438-440 ST. JOHN STREET

APPLICATION FOR PERMIT

AP 440 St. John St. - Alteration of side piazza

440 St. John Street-Construction of front platform, hood and steps for and by
Frank M. Saniuk

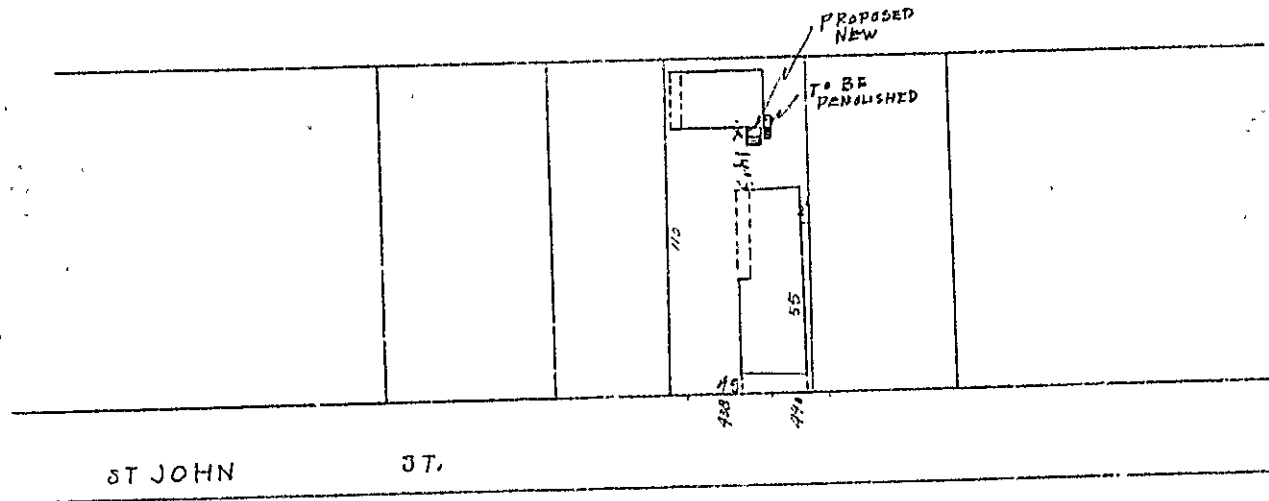
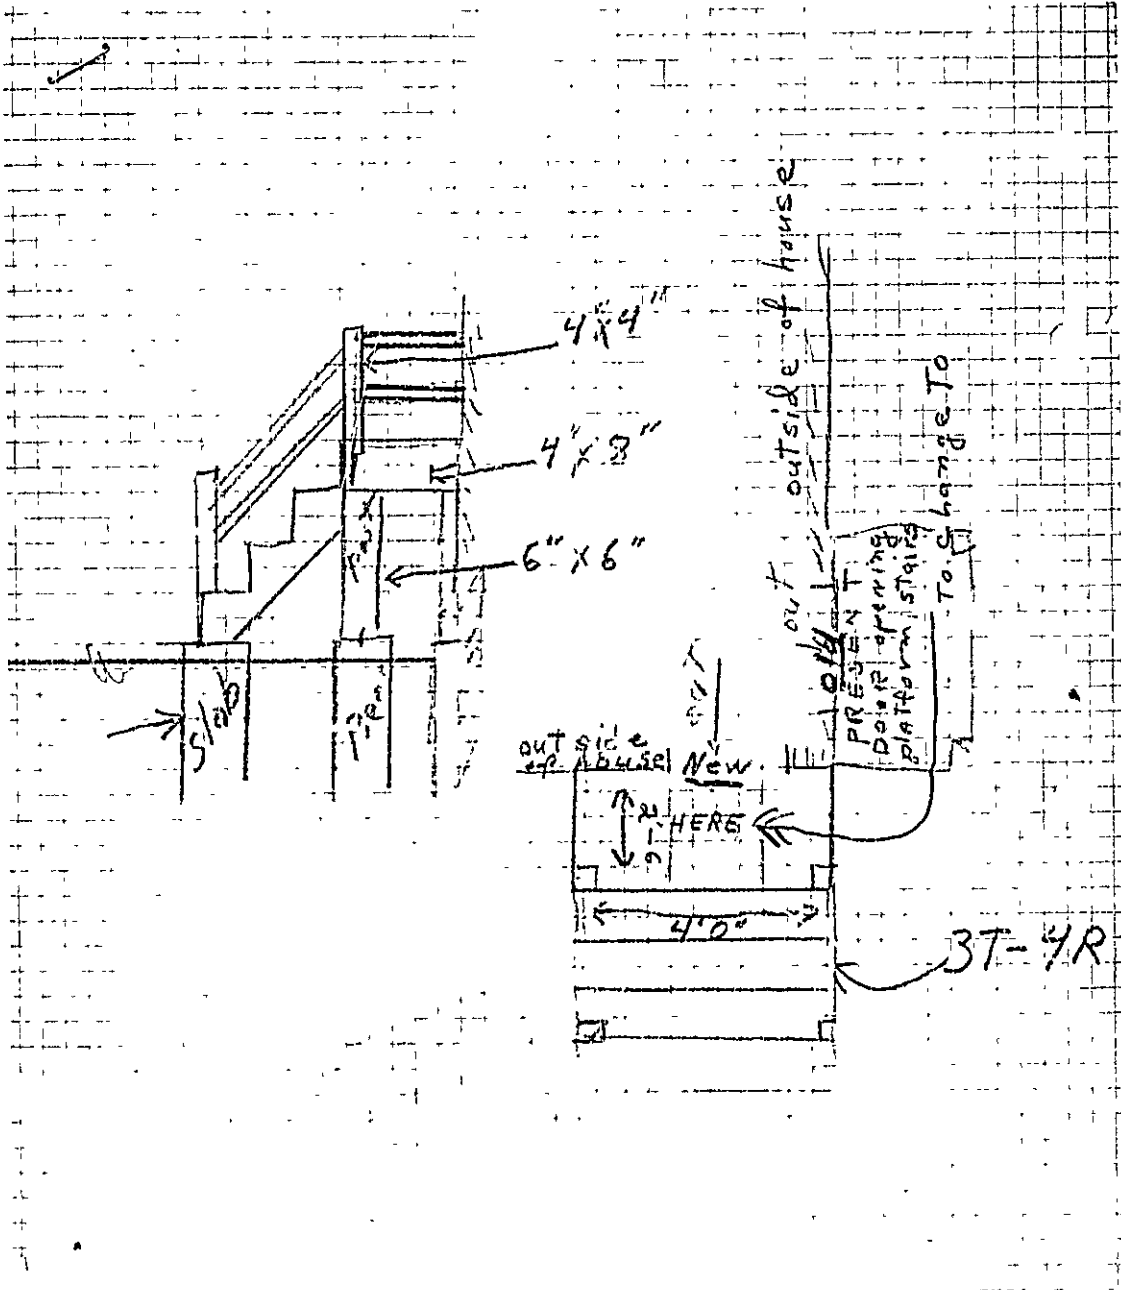
A building permit for demolishing existing entrance platform and steps on side of dwelling at the above named location and constructing a new platform 2½ feet by 4 feet on front of building is not issuable because there is only about 14 feet between the front wall of the dwelling in question and the rear wall of another dwelling on the same lot, thus creating a situation whereby the rear dwelling is already encroaching upon the 20-foot depth of rear yard required by Section 7-B-1 of the Zoning Ordinance for the front dwelling, and the proposed platform would therefore further increase this encroachment.

This further encroachment, while of a minor nature, prevents issuance of the permit. However, you have the right to ask the Board of Appeals for a variance from the precise terms of the Ordinance and, while I cannot speak for the members of that body, it seems likely that they would give sympathetic consideration to such a request on your part. If you desire to exercise your appeal rights, you should go to the office of the Corporation Counsel in Room 208, City Hall, where appeals are filed and where a copy of this letter is being sent.

440 St. John Street-- demolition existing 7'x22' open piazza and to construct
6'x7' open piazza for and by Frank N. Saniuk--April 29, 1952

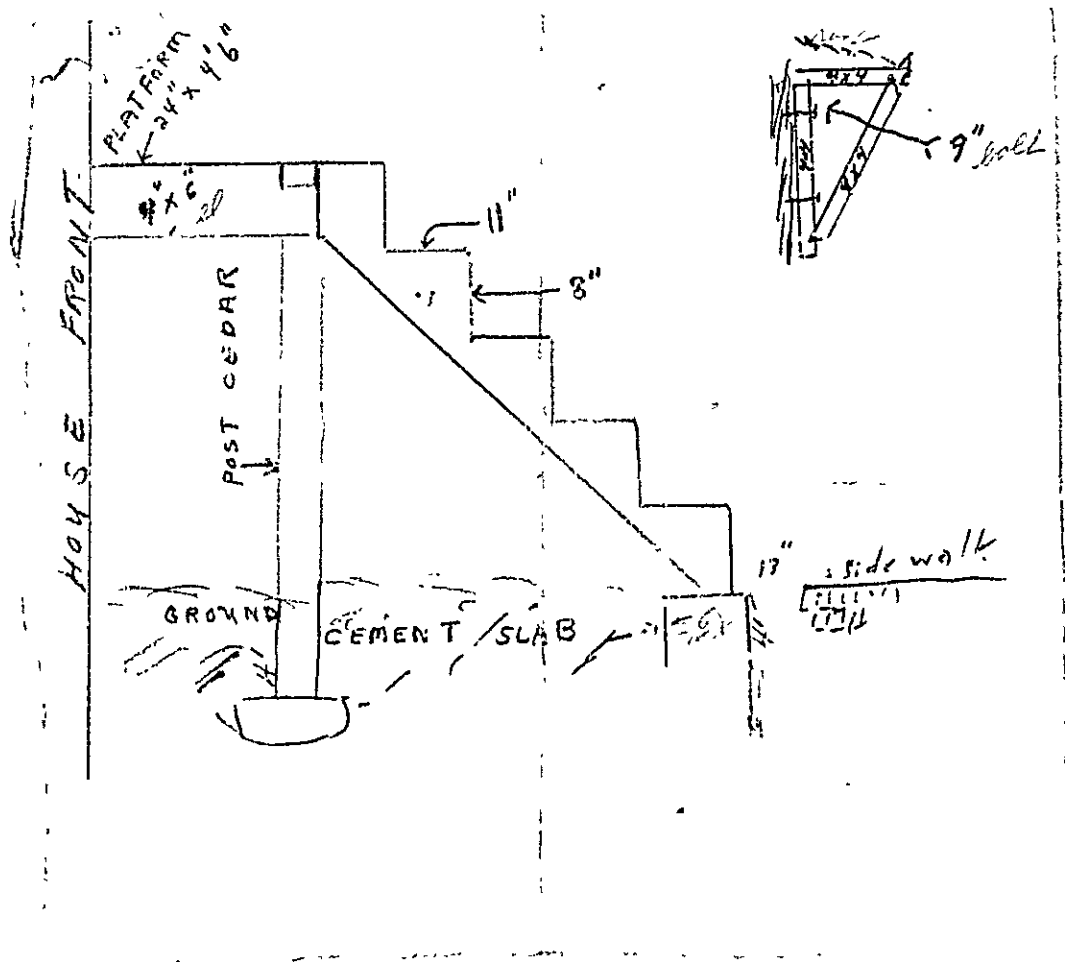
Amendment #1 to permit 51/1695, covering demolition of existing open
piazza 7'x22' on the front of your building at 440 St. John Street and con-
structing of an open piazza 6'x7' in its place, is issued herewith subject to
the following:

1. The 4x6 sills are to be all one piece in cross section, set with
the 6" dimension upright, with the floor timbers supported on top of them or
notched over no less than 2x3 nailing strips spiked to the sides of them.
2. Since the new porch is to have a shed roof, presumably sloping
toward the street, arrangement will need to be made by means of gutters and
downspouts to prevent drainage from the roof flowing upon the public sidewalk.

440 ST. JOHN STREET.

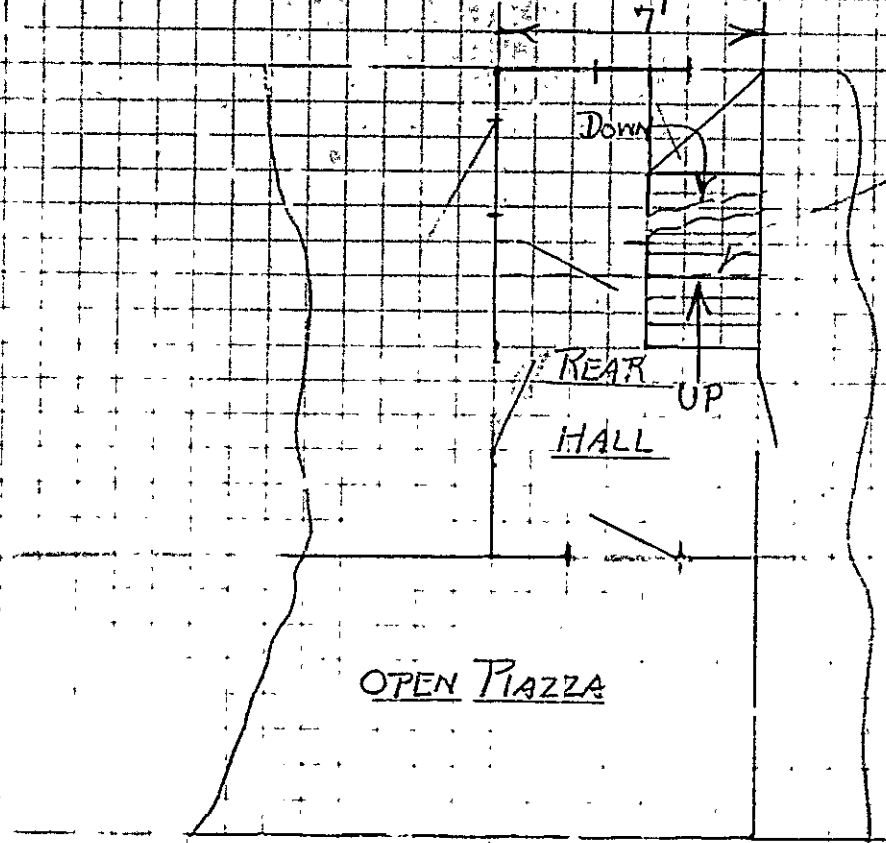
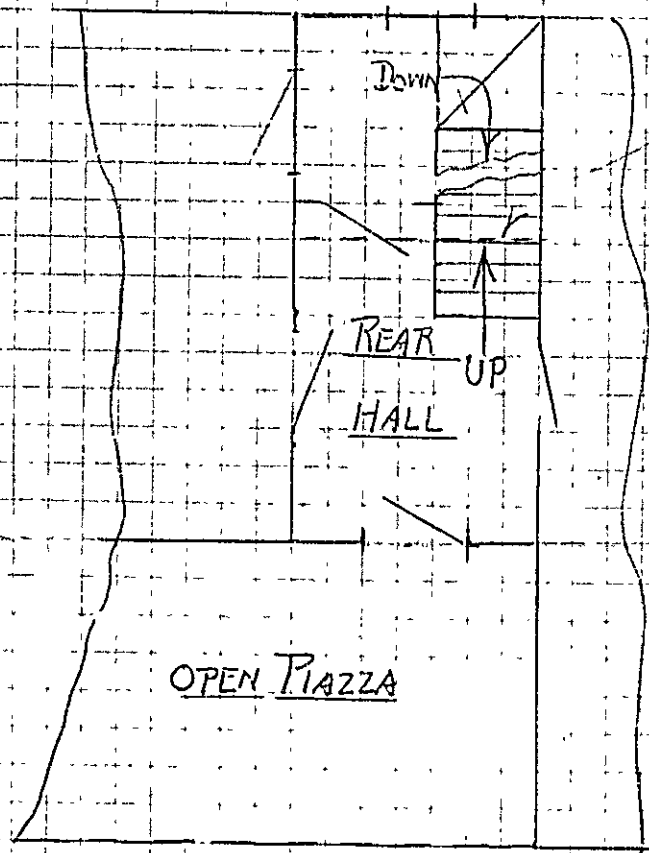
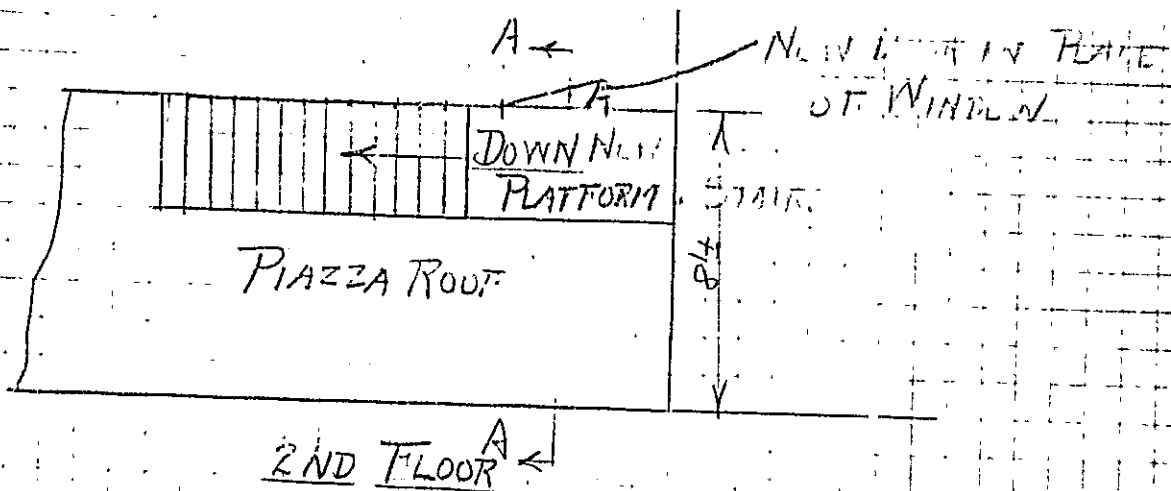
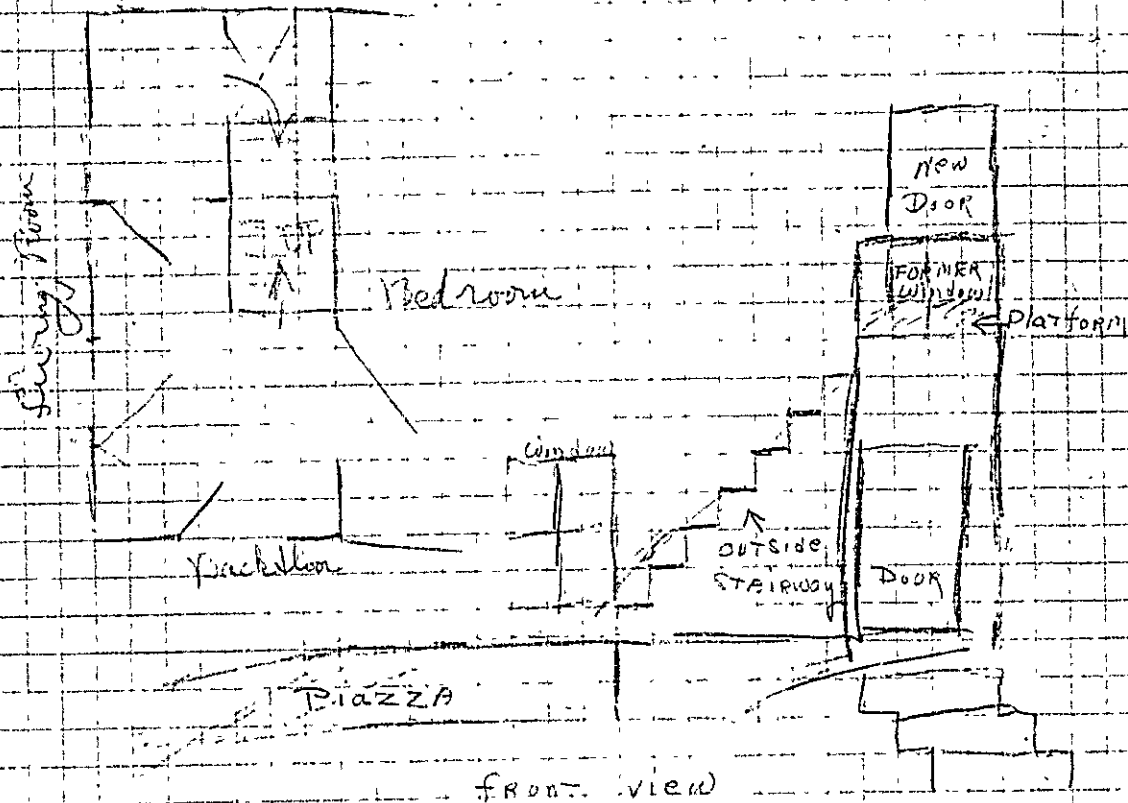
We shall need more information concerning the work proposed before we shall be able to issue the permit. A layout plan of the second floor should be furnished showing the proposed use of the rooms, the location of windows and stairways and any partition work that may be necessary. You should also indicate whether there is an existing window for ventilation of new first story bathroom, or, if not, how it will be ventilated.
